**ADDENDUM**  
**MEETING OF THE PLANNING COMMITTEE**  
**WEDNESDAY 27<sup>th</sup> JULY 2022**

**PLANNING APPLICATION: 21/03303/F - Titan House Crossoak Lane Salfords  
Surrey RH1 5EX**

### **PLANNING APPLICATION: 22/00557/F 80 CROYDON ROAD REIGATE SURREY RH2 0NH**

STATUS <b>PLANNING</b>	DRAWN BY PT	CHECKED BY -
JOB NO. A4260	DRAWING NO. 2301	REV <b>P1</b>
DRAWING TITLE <b>Proposed GA Sections</b>

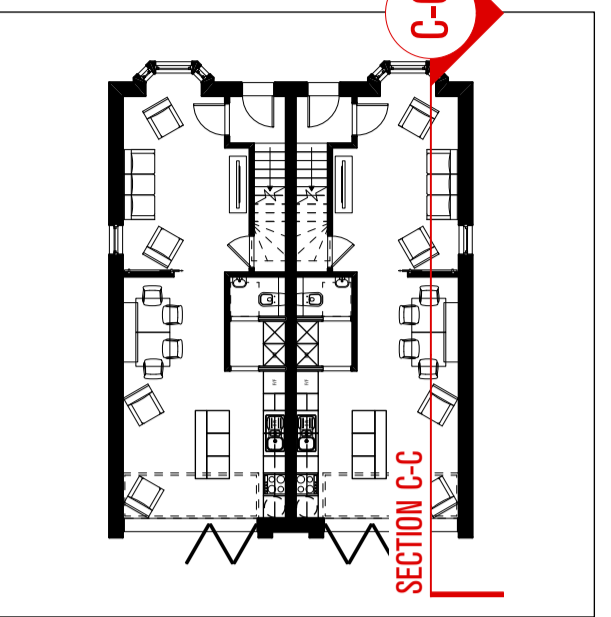
The applicant has provided an additional cross section to more clearly illustrate the height of the proposed rear rooflights. The plans show that the cills of these windows would be 1.7m above floor level, which would allow for minimal views to the rear so as to negate harmful overlooking from the second floor bedrooms. This plan can be found in **Appendix C**.

<b>Plan type</b>	<b>Reference</b>	<b>Version</b>	<b>Received</b>
Street Scene	2205	P2	26.04.2022
Elevation Plan	2200	P2	26.04.2022
Floor Plan	2100	P2	26.04.2022
Location Plan	0001	P1	09.03.2022
Site Layout Plan	1000	P1	09.03.2022
Floor Plan	1100	P1	09.03.2022
Elevation Plan	1200	P1	09.03.2022
Street Scene	1205	P1	09.03.2022
Section Plan	1305	P1	09.03.2022
Proposed Plans	2002	P1	09.03.2022
Site Layout Plan	2000	P2	26.04.2022
Proposed Plans	2001	P1	17.06.2022
Section Plan	2305	P1	09.03.2022
<b><i>Section Plan</i></b>	<b><i>2301</i></b>	<b><i>P1</i></b>	<b><i>22.07.2022</i></b>
